**AUDIT OF WILDLIFE LOSS ASSESSMENTS
FOR FEDERAL DAMS ON THE
COLUMBIA RIVER AND ITS TRIBUTARIES**

Project No. 73485

February 1993

FIGURE 3.1. The Grand Coulee team assessed impact by comparing HUs between 1941 (pre-project, point D1) and 1942 (post-project, point C1). Other teams assessed impact between points C and D1.

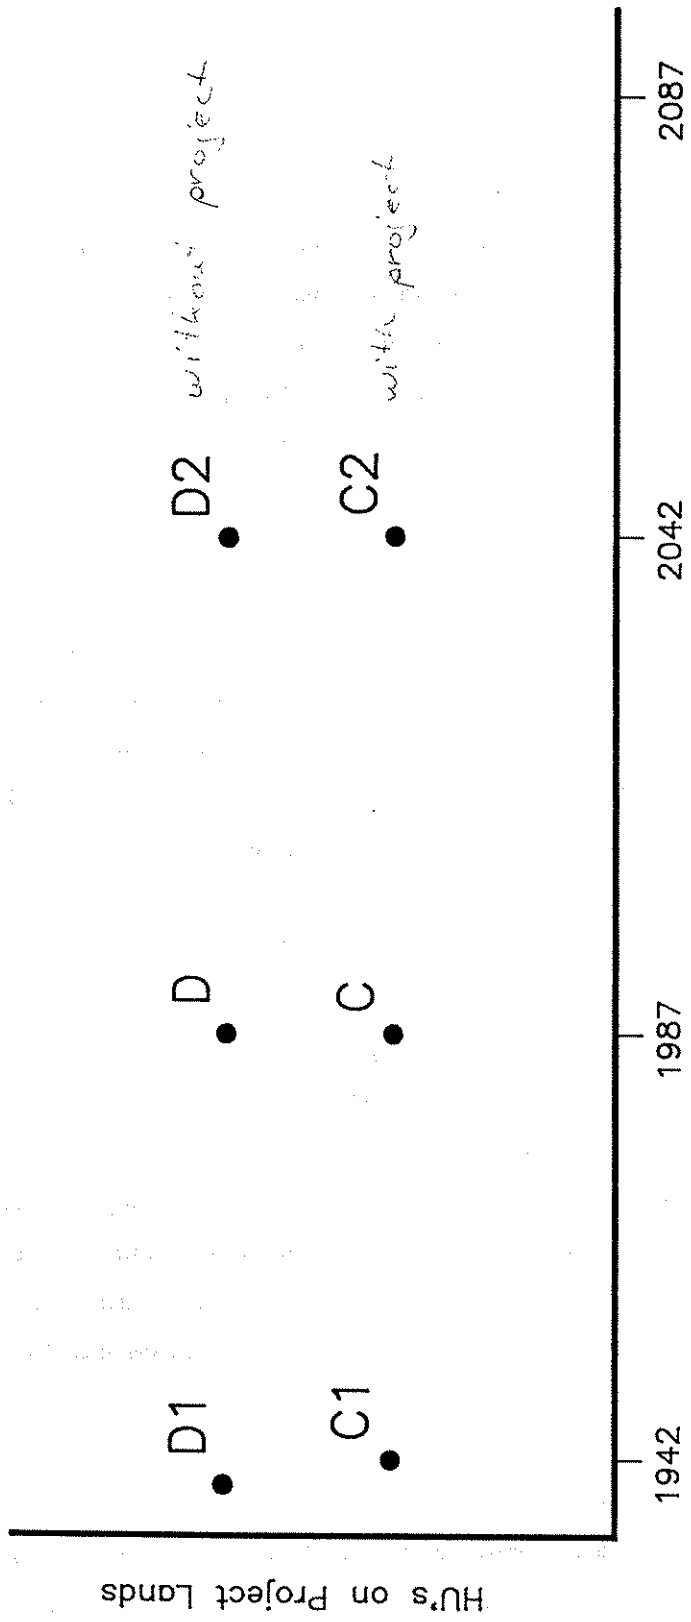
The accuracy of Point C1 (Figure 3.1) is also a concern expressed in several letters in the Wildlife Record. These letters indicated there was no net benefit given for species that use the reservoir. Since this issue appeared several times I reviewed the appropriate data in the project file.

I determined that the Grand Coulee HEP team gave post-project credit for the Canada goose, but no other species. The with-project credit was less than the loss and there was a net loss of goose secure nest sites. This seemed appropriate and is discussed further under the Reservoir Crediting issue. The goose was evaluated using secure nest sites as units of loss rather than HUs. Use of secure nest sites is unconventional according to the HEP manual. As a consequence, goose crediting for this project cannot be compared to the goose HUs estimated by the other HEP loss assessments.

Figure 3.2. The shaded area illustrates the total impact over time (100 years) for the Grand Coulee project.

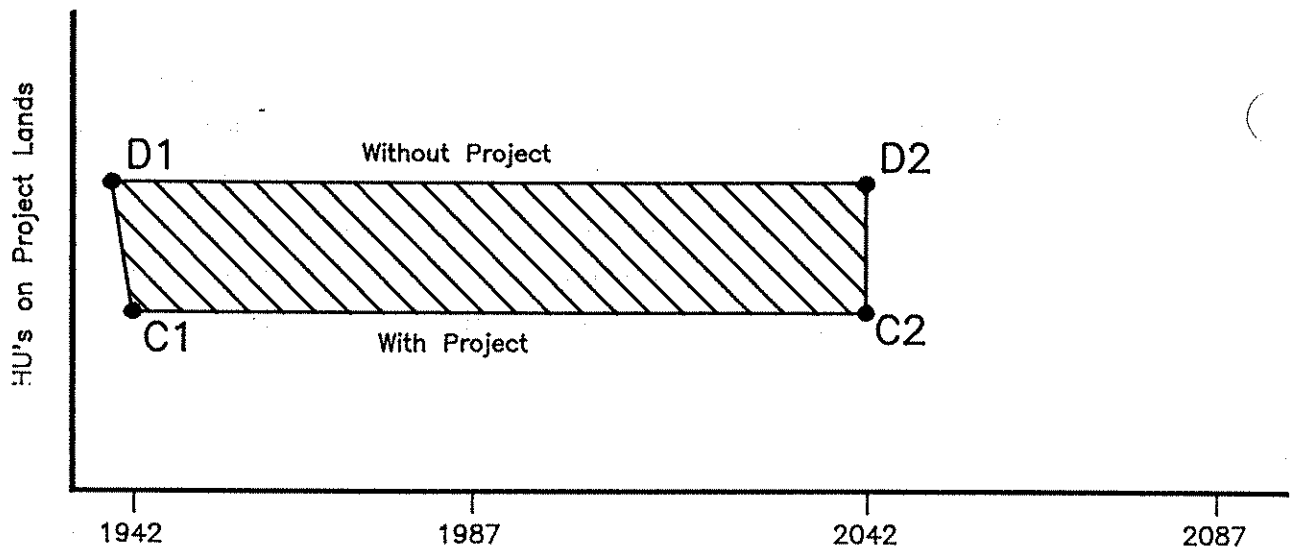
Impact as presented in Figure 3.2 is based on a variety of assumptions. I will evaluate two of these assumptions: 1. Without project HUs are constant, and 2. With project HUs are constant. What is the likelihood that without project HUs would have stayed the same had the project not been built (line D)? Figure 3.3 illustrates the potential consequences of habitat deterioration as assumed by the HEP team (e.g., loss assessment, page 16). The HEP team makes reference to reduced habitat quality on adjacent project lands (e.g., loss assessment, page 14 and 20). They indicate adjacent project lands are similar to the inundated area and that reduction in habitat value on the adjacent lands is likely to be similar to the reduction in habitat value that would have occurred if the project had not been built. No information is given as to the extent (e.g., slope of the D1 to D3 curve of Figure 3.3) of habitat loss that might have occurred had the project not been built. The HEP team might be correct to assume that habitat on adjacent land has deteriorated since the project was built (line D1 to D3). However, I am not aware of any information that indicates wildlife habitat has deteriorated more than 25% ($D2 \text{ minus } D3 \div D2$, Figure 3.3) since the project was constructed.

If the HEP team is correct and habitat has deteriorated to some extent, impact in the loss assessment, has been overestimated (by the amount of the deterioration) relative to other HEP loss assessments. The integrated (shaded) area under (Figure 3.3) ~~with~~ line D1 to D3 would be less than the shaded area in Figure 3.2 if habitat deteriorated as assessed by the HEP team. Since the HEP team did not account for this reduction in impact by annualization, they over estimated impact. As stated above, the over estimate is likely to be less than 25%.

Figure 3.4. Changes in reservoir conditions for wildlife could influence assessment estimates. A decrease in reservoir value for goose nesting over time (curve C1-C4) would result in greater total impact (shaded area).

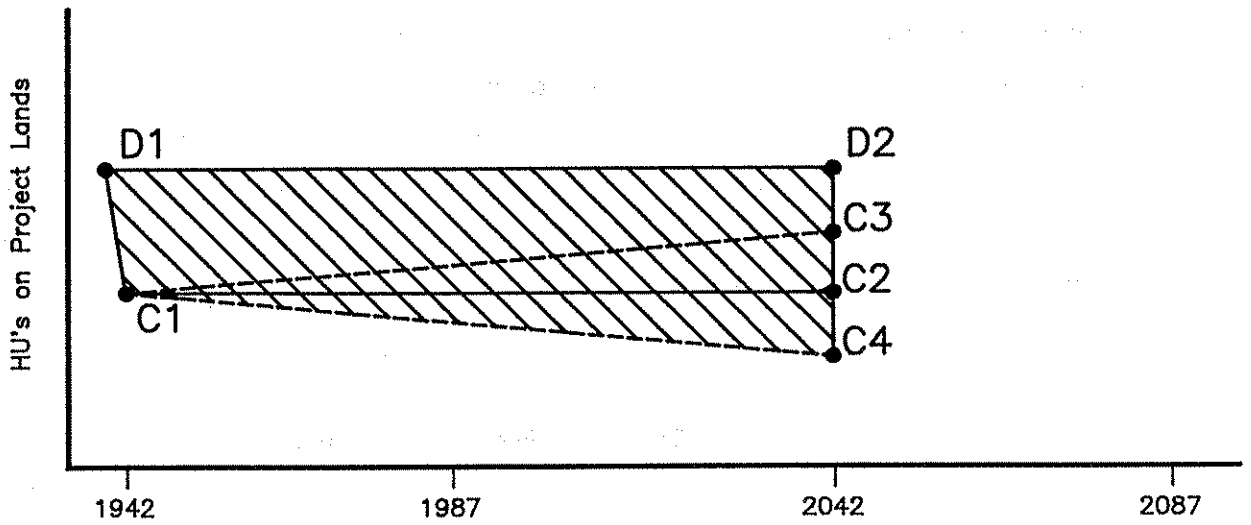
With project (reservoir) HUs (line C1 - C2, Figure 3.4) were also assumed to remain constant. It is possible that more waterfowl used the reservoir as resident fish populations expanded and as riparian areas developed (albeit limited considering the topography and reservoir operation). If reservoir conditions did improve for waterfowl over time, line C1-C3 would have a positive slope and annualized impact would be less. If reservoir conditions deteriorated over time, line C1 - C4 would have a negative slope. For example, it is recognized that potential nesting habitat along the reservoir or on islands is hampered by extensive reservoir slumping (loss assessment, page 15). The HEP team informed me that reservoir bank slumping continues to occur and that the amount of goose nesting on islands is not increasing and may be decreasing. I received no information that indicates deterioration in reservoir habitat due to bank slumping would be a bias. The slumping area while extensive is small in comparison to the area of the reservoir.

Figure 3.5. Mitigation is illustrated as enhancement (area above curve E-F) and preservation (area below curve E-F). Total mitigation is illustrated by the vertical shaded area.

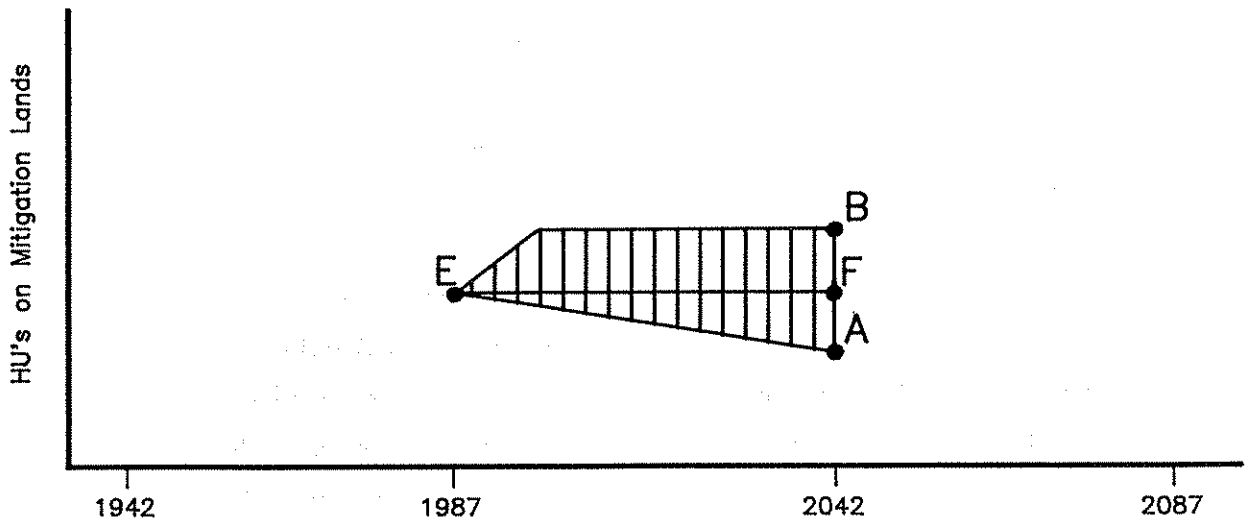
The Grand Coulee HEP team displayed two types of mitigation in their hypothetical assessment of annualization. Enhancement is shown as the area above curve EF and preservation is shown as the area below curve EF (Figure 3.5). The team assumed that mitigation could reach 100% sometime in the future when line AB (Figure 3.5) = line CD (Figure 3.2). In other words, when mitigation occurs on enough acres with enough benefit to equal losses between Years "0" and "1", the team indicated mitigation is adequate. The mitigation that occurs from 1987 to 2042, illustrated as a shaded area (Figure 3.5), is much smaller than the impact shaded area in Figure 3.2

and is not adequate to offset impact. Approximately four times the mitigation shown in Figure 3.5 would be required to compensate for 100 years of impact.

Figure 3.6. Total mitigation (vertical shaded area) for 100 years is less than total impact for 150 years (diagonal shaded area). Additional mitigation is needed to compensate for 45 years of ongoing impact.

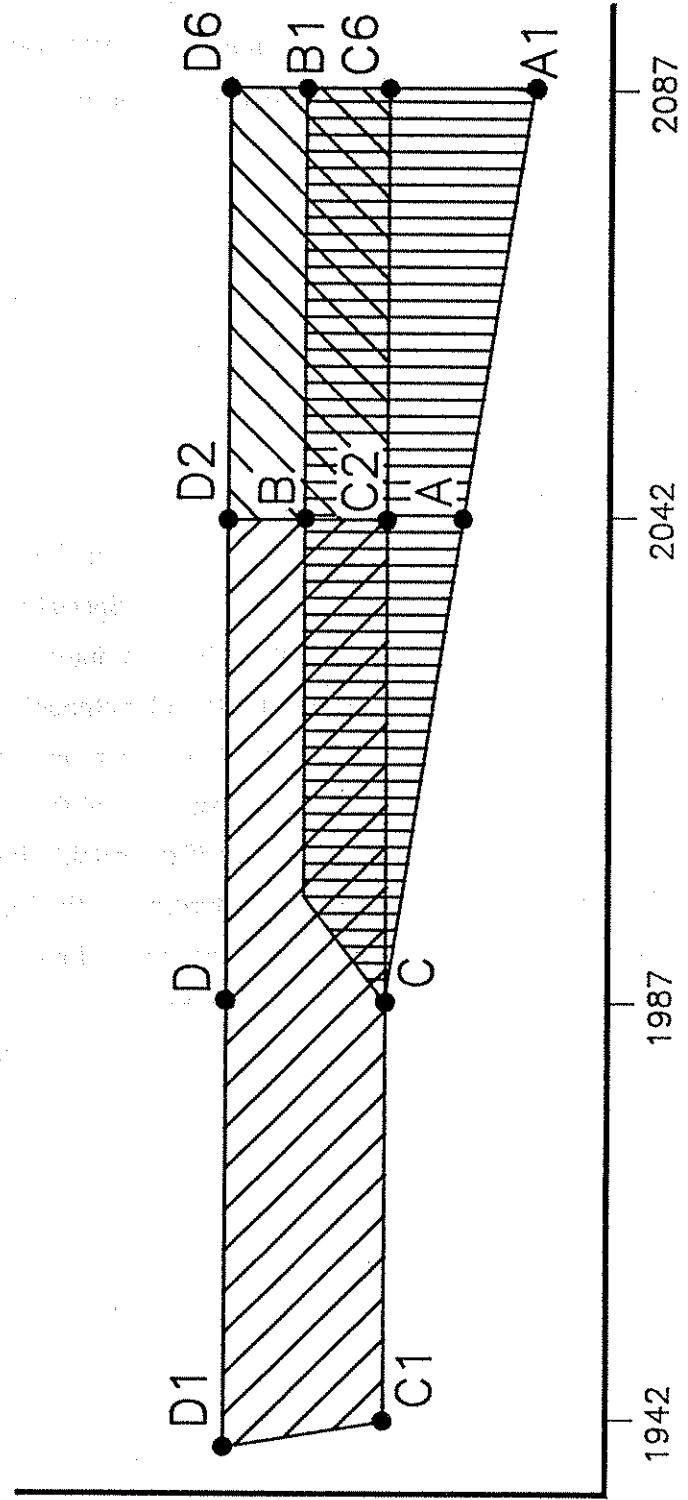
The amount of mitigation to compensate for 100 years of impact will be less if mitigation is modeled to run for 100 years (Figure 3.6). For example, the area of accumulated mitigation (Figure 3.6) appears to be more nearly equal to the area of the impact (Figure 3.2). However, mitigation as illustrated in Figure 3.6 is not equal (in area) to the impact in Figure 3.6 because as the mitigation accumulates between years 2042 and 2087, impact also continues to accumulate (see impact area under line D2 to D6, Figure 3.6). Mitigation implemented 45 years after the project was built does not catch up with the ongoing impact. To the extent that mitigation can't catch up, impact is underestimated. The extent of the underestimate is the amount of impact that has accumulated since construction (1987 minus 1942 or approximately 45 years or 45% of the 100 years of impact). This underestimate of impact, if not addressed with increased mitigation, is real and should be considered a bias against all projects, especially the older projects. Another way to look at the bias against older projects is discussed for the McNary project which compares losses for each of the projects assessed, assuming the projects are all the same size.

Figure 3.7. Older projects such as Grand Coulee and McNary have incurred more impact than more recent projects such as Dworshak. This figure assumes all the projects had similar impacts due to construction

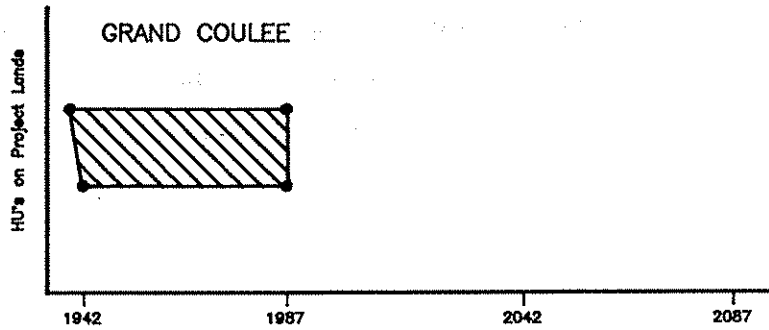
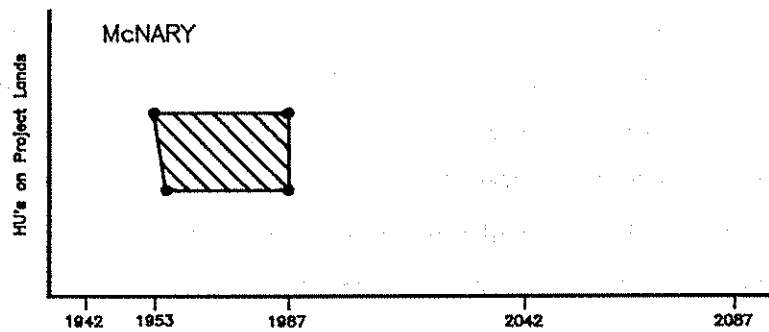
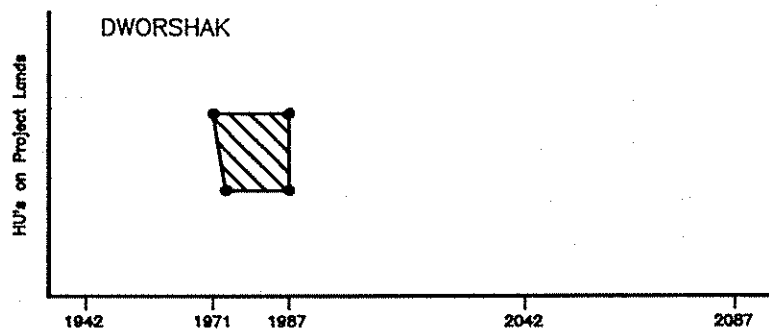
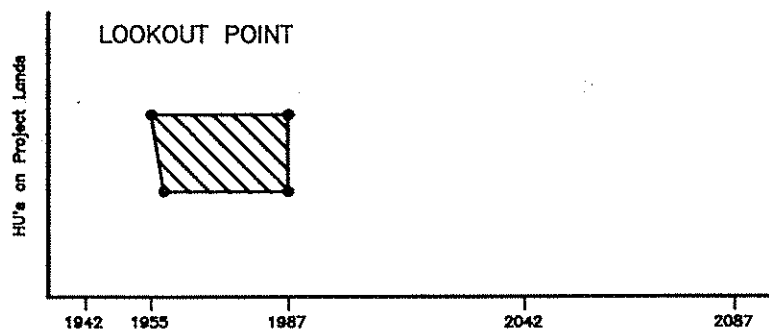
The McNary project (Figure 3.7) is approximately 10 years younger than the Grand Coulee project (Figure 3.2). As a consequence the McNary project has resulted in 35 (1987 - 1952) years of loss while the Grand Coulee project has resulted in over 45 years of loss. At this point in time, the McNary project has resulted in approximately 20% less total loss than Grand Coulee if one considers only the time difference (in) the projects have been in place. As discussed for the Grand Coulee project, the lack of some type of annualization analysis to account for the difference in age between the projects should be considered a systematic bias against all projects, especially the older projects.

Figure 3.8. Benefits related to forest succession have been accounted for in the impact (C2-D4). The shaded area shows benefits that should not have been counted

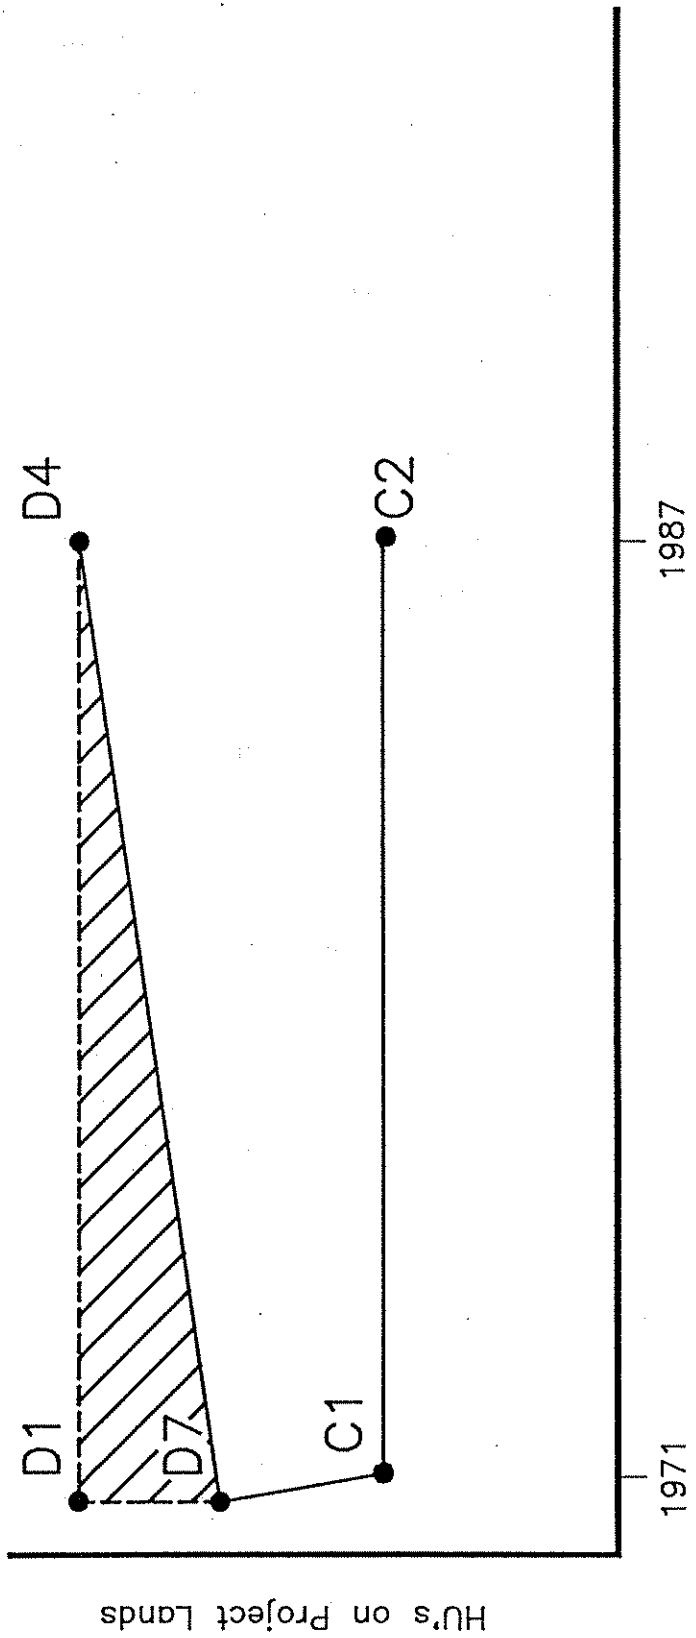
The consequences of not accounting for successional changes that have occurred can only be estimated by conducting an annualization analysis. Such an analysis is beyond the scope of the audit, but would probably indicate that impact was overestimated for species that benefit from mature cover types (e.g., pileated woodpecker). The overestimate is due to counting all the benefits of the mature forest from the day the project was built rather than gradually as the forest matured. Line D7 - D4 (Figure 3.8) shows an increase in slope from the past (1970) to the present (1987). The increase in slope is due to a gradual increase in HUs as the forest matures. The assumption of instantaneous maturation (see above) made by the Dworshak team, (i.e., present conditions have

occurred from the start of the project to the present) will result in an overestimate of loss. The amount of overestimate is depicted by the shaded area in Figure 3.8. This shaded area represents the difference between instant maturation (a Dworshak project assumption) and gradual maturation. The shaded area would be accounted for in the Dworshak loss assessment as it was conducted (i.e., the difference between D4 and C2 in Figure 3.8). However, the shaded area would not be accounted for in an annualization analysis because the forest wasn't mature when the project was built. It is beyond the scope of the audit to determine if the overestimate is a bias.

Figure 3.9. The Willamette team did not account for forest management that would likely have occurred on project lands. The shaded area illustrates a loss in habitat value (without project) that should not have been accounted for in the impact assessment.

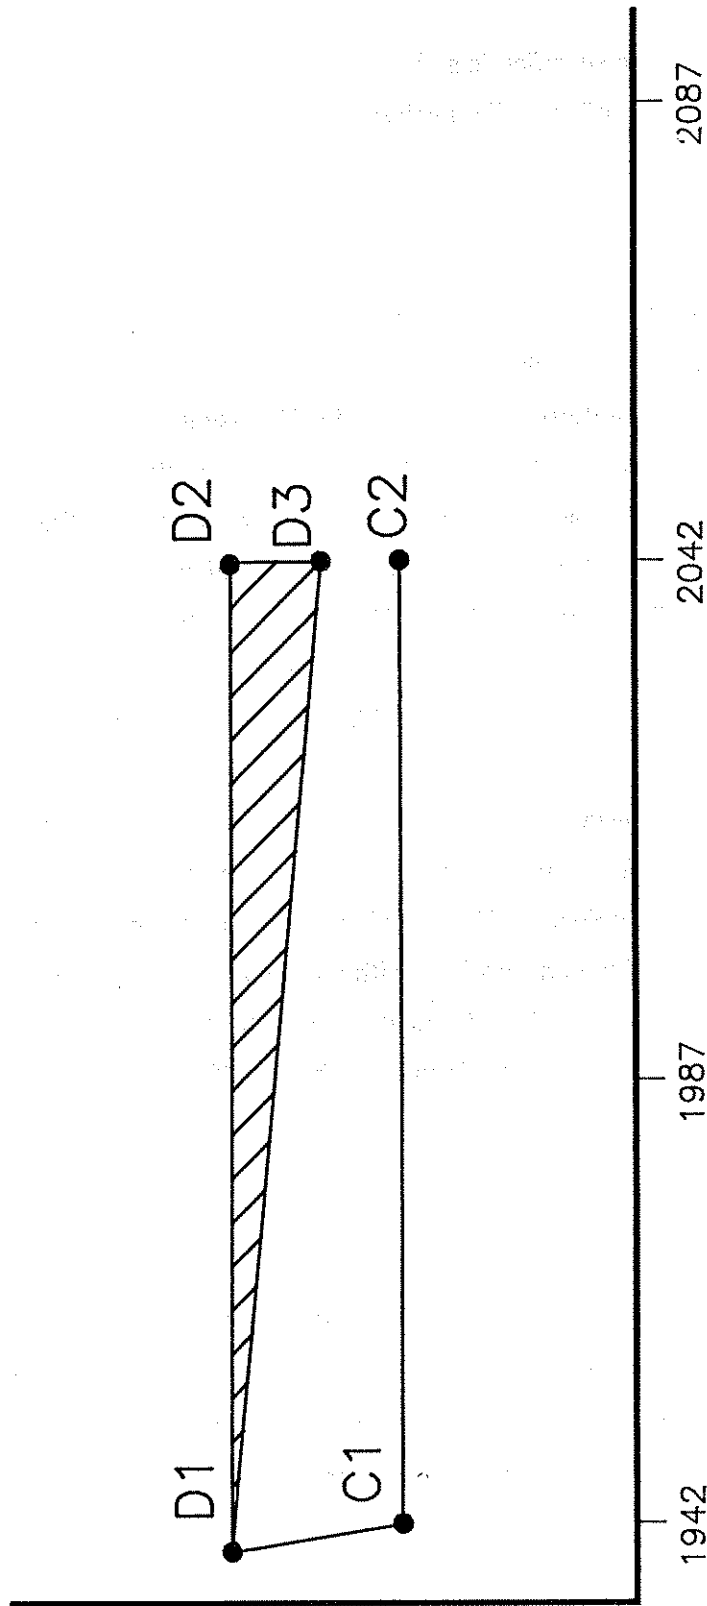
A 50% reduction in habitat value of the affected area, as illustrated in Figure 3.9, relates (approximately) to a 25% loss over time (e.g., the shaded area above the with-out project curve, D1 to D3). The accuracy of this prediction is based on knowing the extent that habitat value in the area of the project has been reduced since the project was constructed.
